Subject: Submittal Supporting Accelerated ABWR Review Schedule - **DFSER Open
Item 3.8.3-1 and COL Action Item 9.4.8-1**

Enclosed are SSAR markups addressing DFSER Open Item 3.8.3-1 and COL Action Item 9.4.8-1.

Figure 9.4-7 SERVICE BUILDING VENTILATION SYSTEM

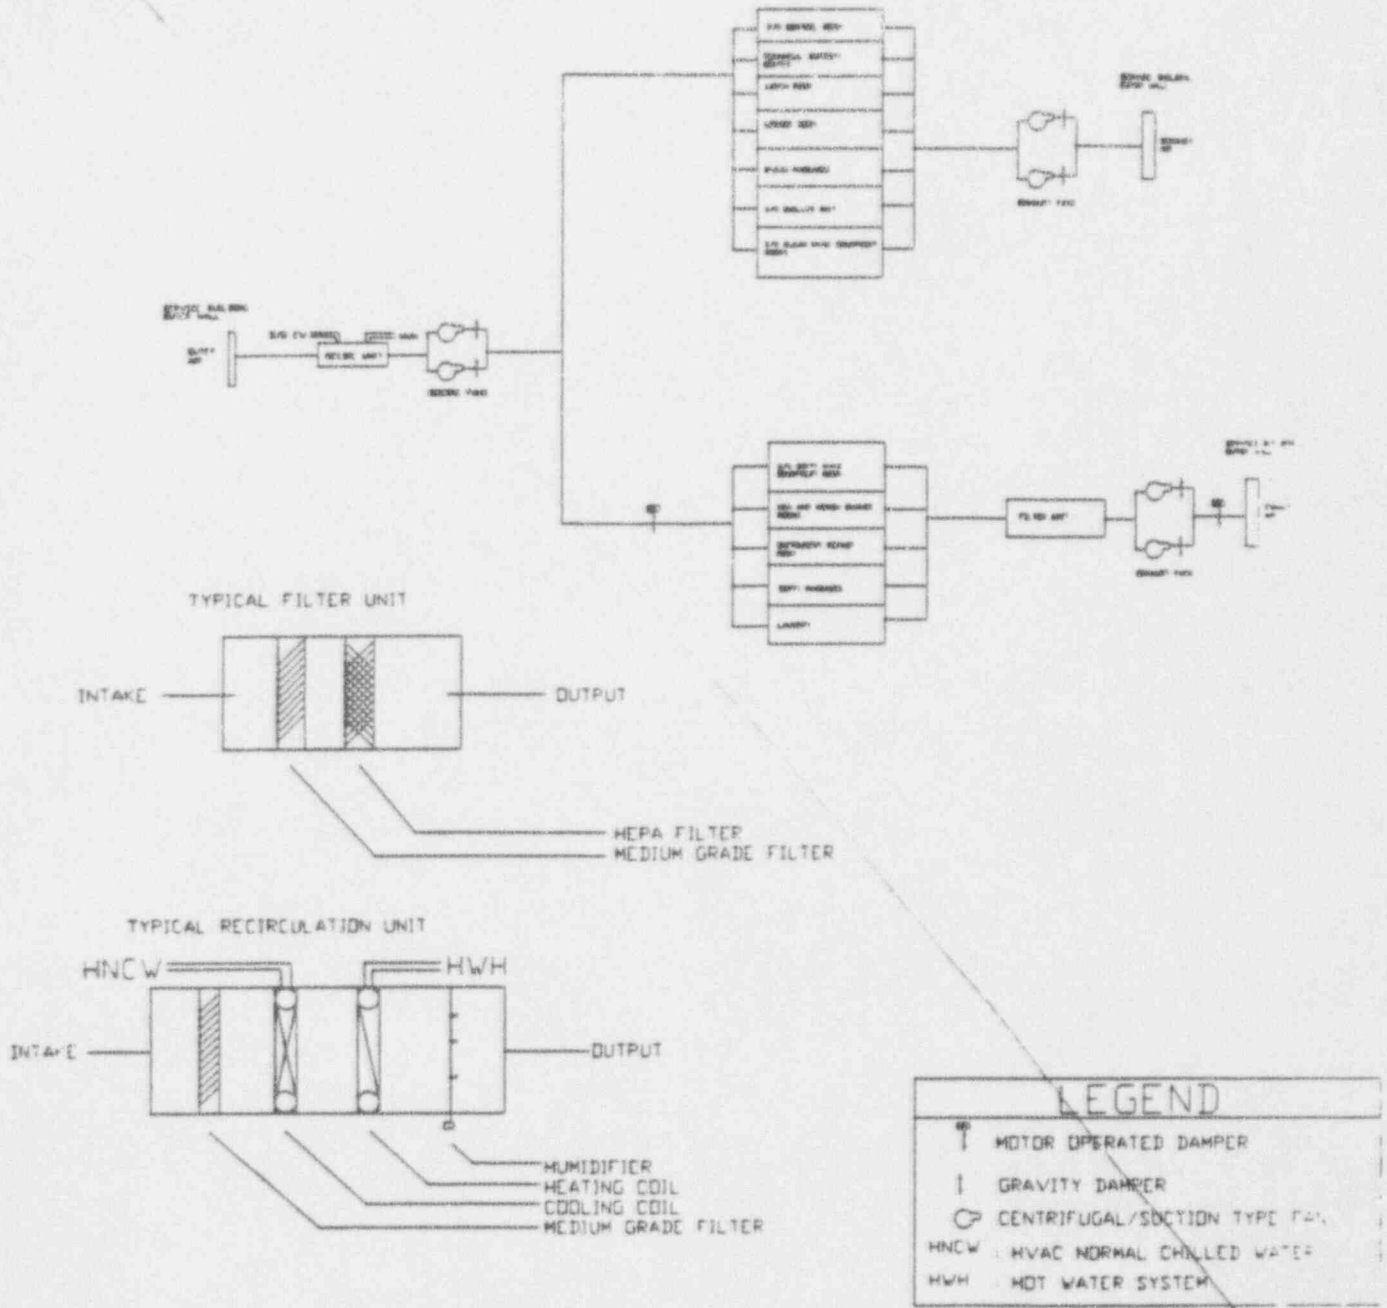
- (1) The schematic design of the service building ventilation system is shown on Figure 9.4-7.
- (2) The service building ventilation system supplies filtered, heated or cooled air to the general areas through a central fan system consisting of an outside air intake, filters, a heating coil, a cooling coil, two 50% capacity supply air fans, and supply air ductwork.

- (5) The clean areas served by the service building HVAC system has an emergency filter train. It is manually operated. In an emergency it supplies filtered air for the TSC and other normally clean areas.

- (6) The clean areas of the service building is provided with an emergency filter train consisting of a heater/demister, prefilter, HEPA filter, 2" charcoal fileter bed, a second HEPA filter, and a fan.

- (8) The COL applicant will provide a detailed P&ID and an equipment list, for the service building HVAC system, including the TSC, for NRC review. (See Subsection 9.4.10.1 for COL License Information)
